MILITARY SPECIFICATION

CIRCUIT BOARD, +24 VOLT CONVERTER, VOLTAGE CONVERTER (PIVADS): 9397385

This amendment forms a part of Military Specification MIL-C-70582B (AR), dated 23 August 1990, and is approved for use by the U.S. Army Armament, Munitions, and Chemical Command, and is available for use by all Departments and Agencies of the Department of Defense.

Figure 1. Burn-in Temperature Versus Time Diagram

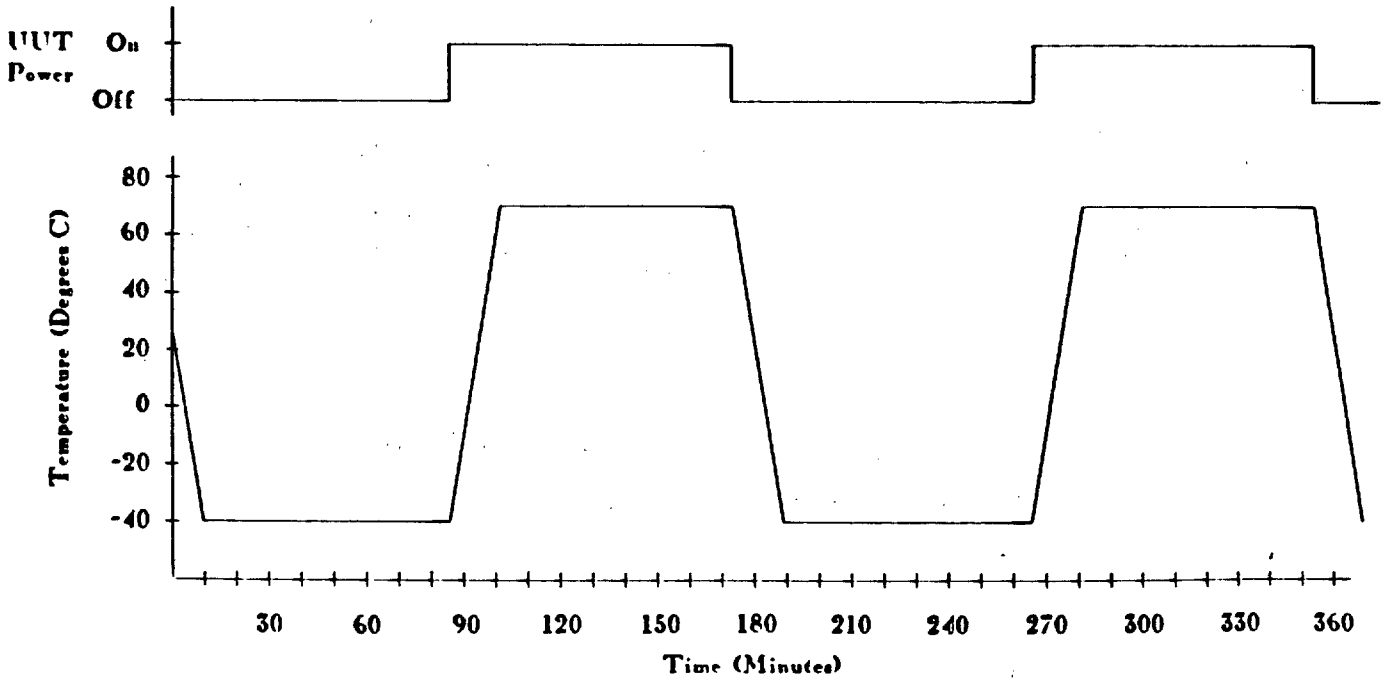
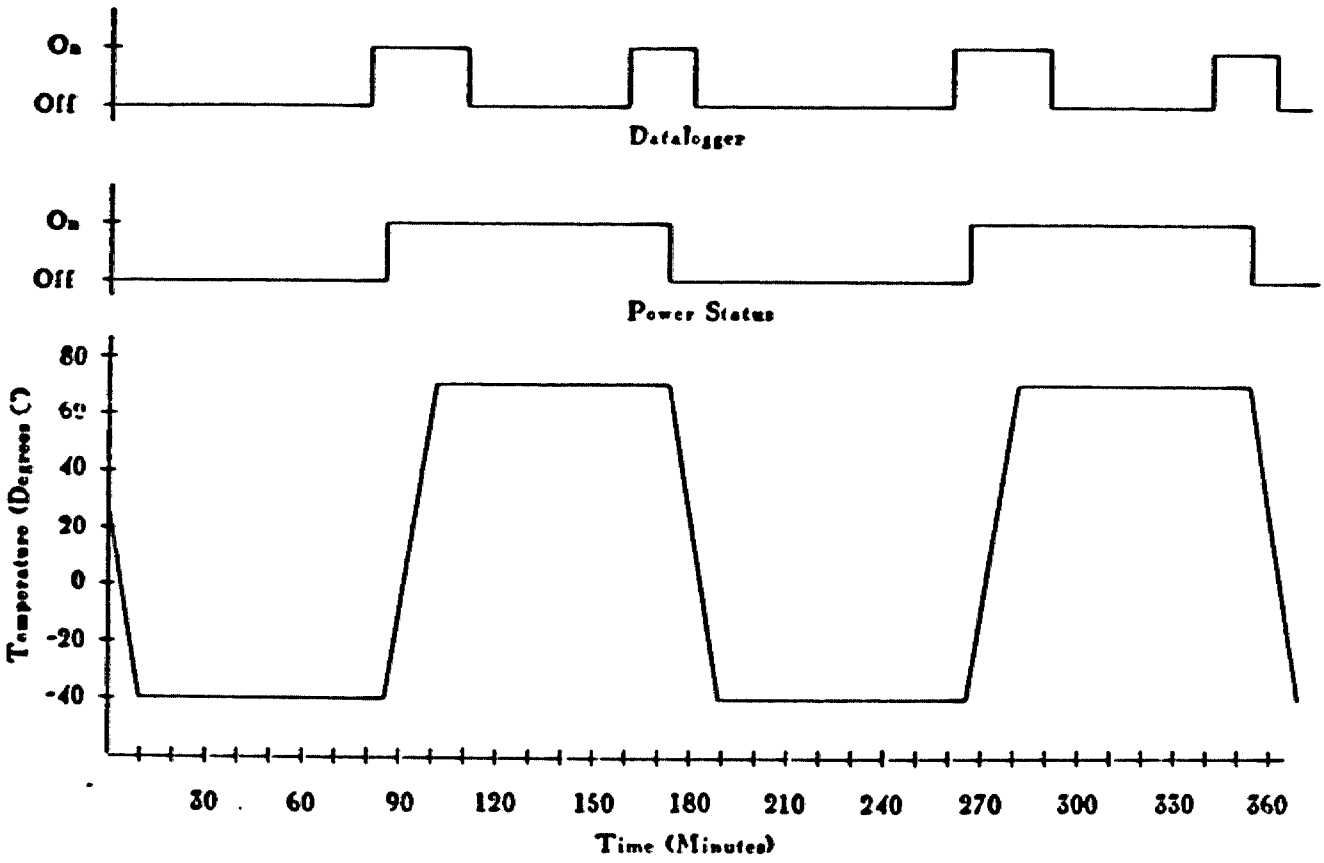
Change from:

TO:
